UNITED STATES PATENT AND TRADEMARK OFFICE

APPLICATION NO.	FILING DATE	FIRST NAMED INVENTOR	ATTORNEY DOCKET NO.	CONFIRMATION NO.
10/629,831	07/30/2003	Akira Tsumiyama	SN-US035024	7279

Office Action Summary	Application No.	Applicant(s)	
	10/629,831	TSUMIYAMA, AKIRA	
	Examiner	Art Unit	
	Vinh T. Luong	3682

ATTACHMENT # 1

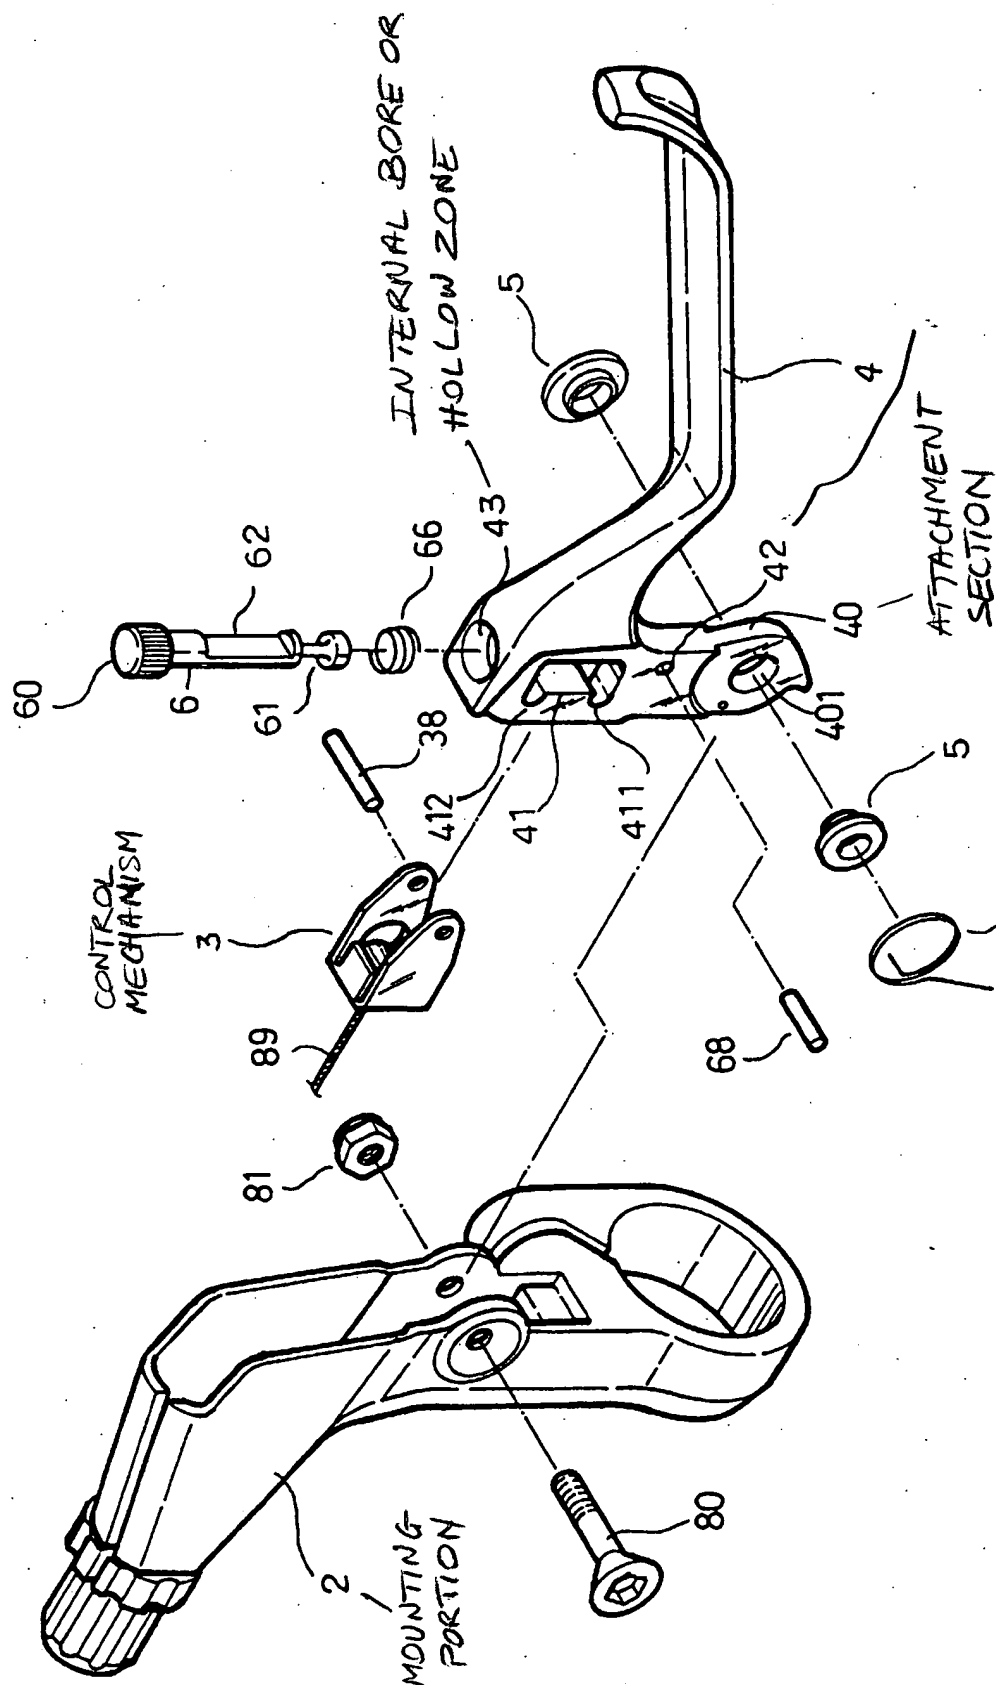
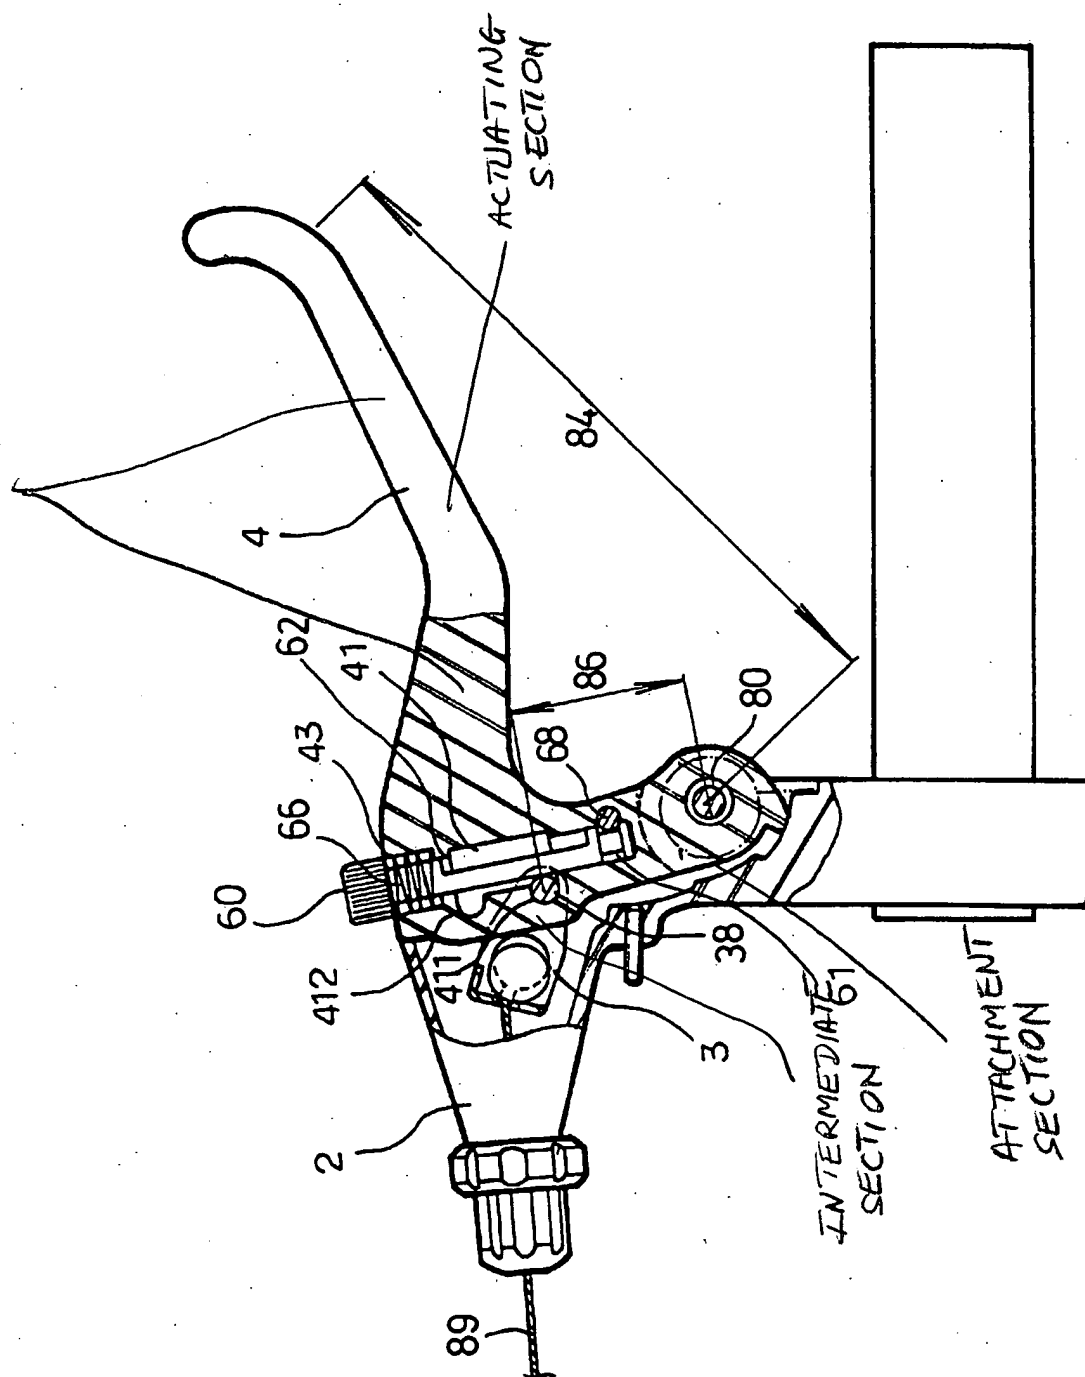
a control lever 4 operatively coupled to the control mechanism 3, the control lever 14 including an attachment section (at 40 in Fig. 1, see Attachment 1), an intermediate section (Att. 1) extending from the attachment section (Att. 1) and an actuating section (Att. 1) extending from the intermediate section (Att. 1), the attachment section (Att. 1) being operatively coupled to the control mechanism 3, *at least one of* the intermediate section (Att. 1) and the actuating section (Att. 1) having a hollow zone 43 formed therein that extends axially along the at least one of the intermediate section (Att. 1) and the actuating section (Att. 1) of the control lever 4, the control lever 4 being constructed of a material having an internal bore 43 (Fig. 1) extending axially to form the hollow zone 43 with the internal bore being surrounded by

the material along a majority of an axial length of the internal bore 43, the internal bore 43 having a substantially circular transverse cross-sectional shape 43 such that the control lever 4 has a non-uniform wall thickness (Att. 1) as measured in a direction transverse to the axially extending internal bore between the internal bore 43 and an external surface of the at least one of the intermediate section (Att.) and the actuating section having the hollow zone 43 formed therein.

a control lever 4 operatively coupled to the control mechanism 3, the control lever 14 including an attachment section (at 40 in Fig. 1, see Attachment 1), an intermediate section (Att. 1) extending from the attachment section (Att. 1) and an actuating section (Att. 1) extending from the intermediate section (Att. 1), the attachment section (Att. 1) being operatively coupled to the control mechanism 3, *at least one of* the intermediate section (Att. 1) and the actuating section (Att. 1) having a hollow zone 61 formed therein that extends axially along the at least one of the intermediate section (Att. 1) and the actuating section (Att. 1) of the control lever 4, the hollow zone 61 being a blind bore that is open at a free end of the intermediate section (Att.).

ATTACHMENT # 2

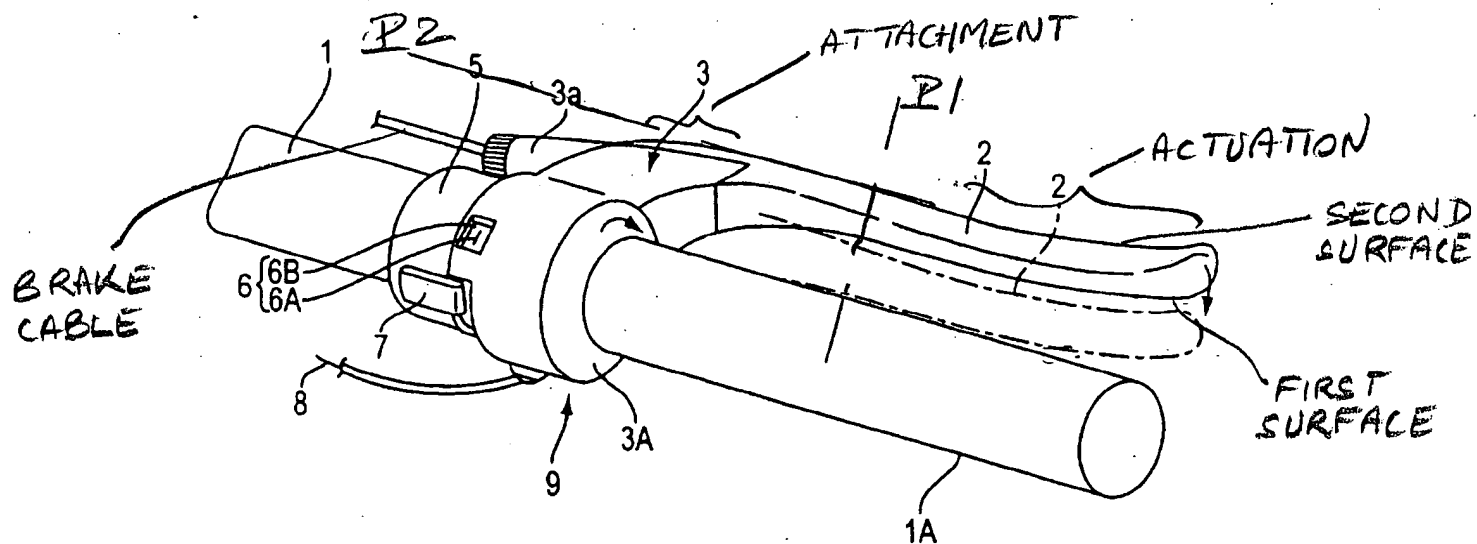
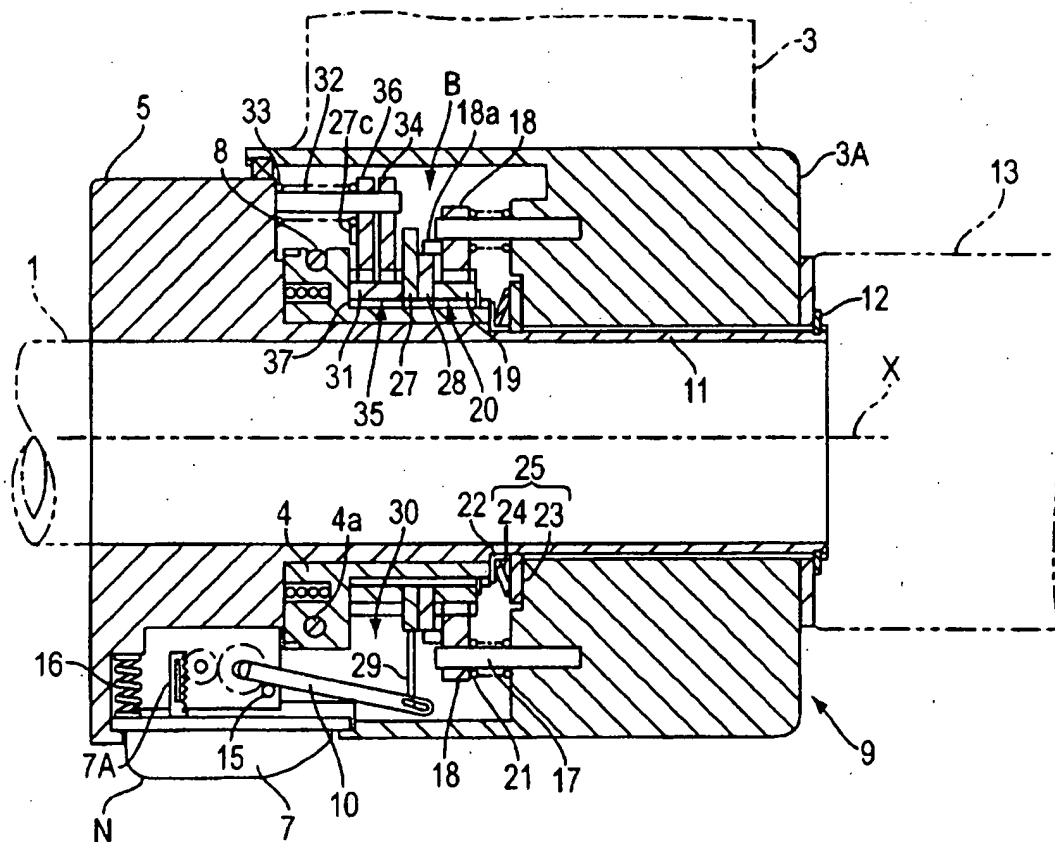
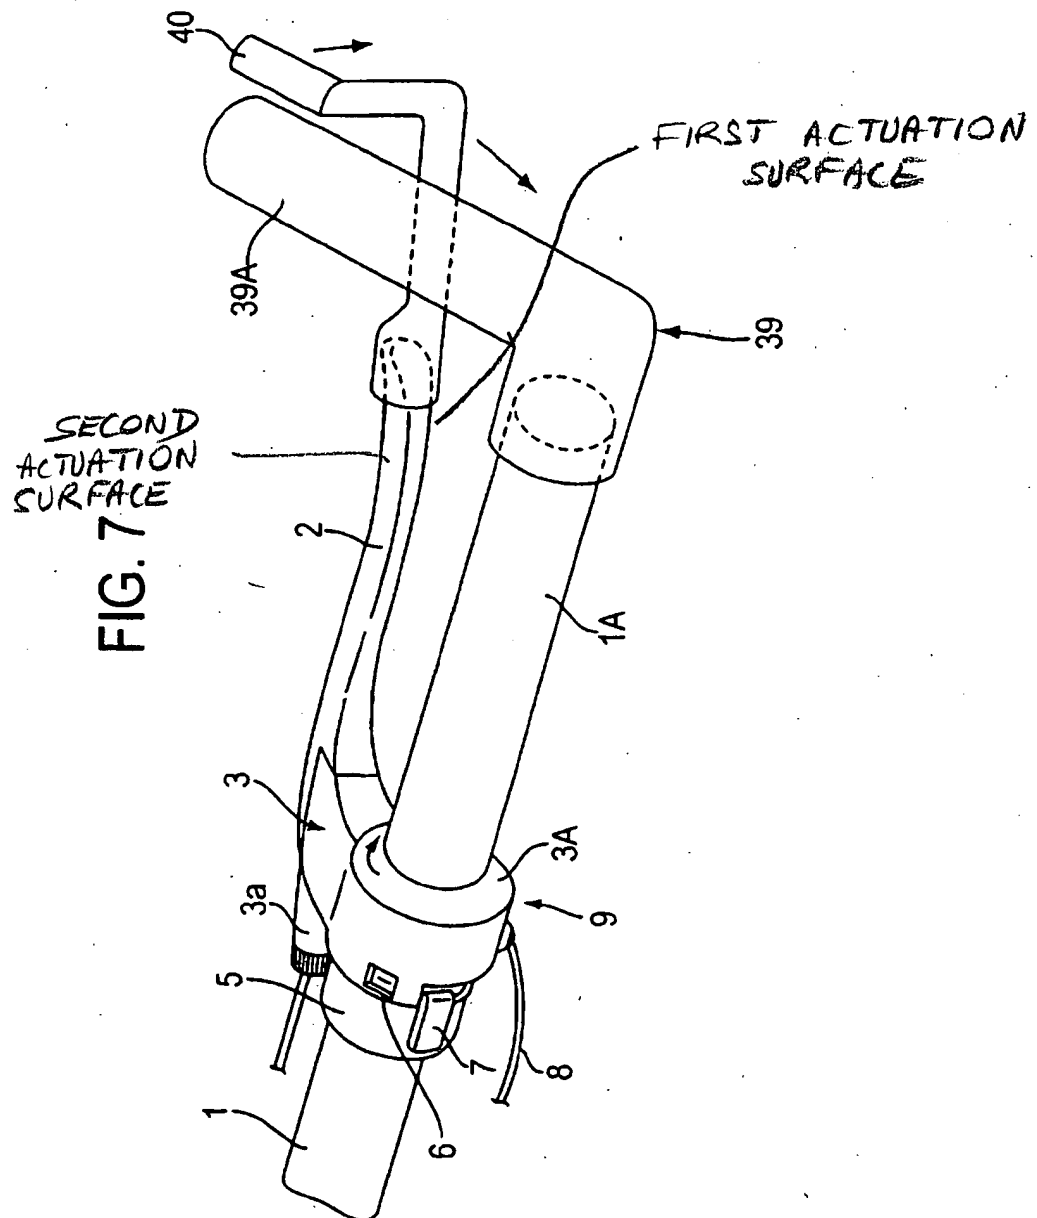
a control lever 2 or 2, 40 operatively coupled to the control mechanism 9 to move along a first plane (P1. See Attachment 2) between a rest position and a operating position and along a second plane (P2, Att. 2) substantially perpendicular to the first plane (Att. 2) between the rest position and a first position vertically spaced from the rest position, the control lever 2 or 2, 40 including an attachment section (Att. 2) and an actuating section (Att. 2) extending from the attachment section (Att. 2), the attachment section (Att. 2) being operatively coupled to the control mechanism 9, the actuating section (Att. 2) having a first actuation surface extending in a direction substantially perpendicular to the first plane and an inclined second actuation surface (Att. 2) facing substantially away from the first actuation surface (Att. 2) downwardly and towards the handlebar 1, 1A, the inclined second actuation surface (Att. 2) extending in a direction intersecting the first and second planes, the inclined second actuation surface (Att. 2) having a transverse height that is at least one-half of the transverse height of the first actuation surface (Att. 2) with the transverse heights being measured in directions perpendicular to the first plane (P1).

Regarding claim 12, the control lever 2 or 2, 40 includes a brake cable attachment portion arranged and configured to pull a brake control cable (Fig. 1, Att. 2) upon movement of the control lever 2 or 2, 40 from the rest position to the operating position when a substantially rearward force is applied to the first actuation surface (Att. 2).

Regarding claim 13, the control lever 2 or 2, 40 is normally biased toward the rest position in order to release the brake control cable (Att. 2) after moving the control lever 2 or 2, 40 to the operating position and releasing the control lever 2 or 2, 40.
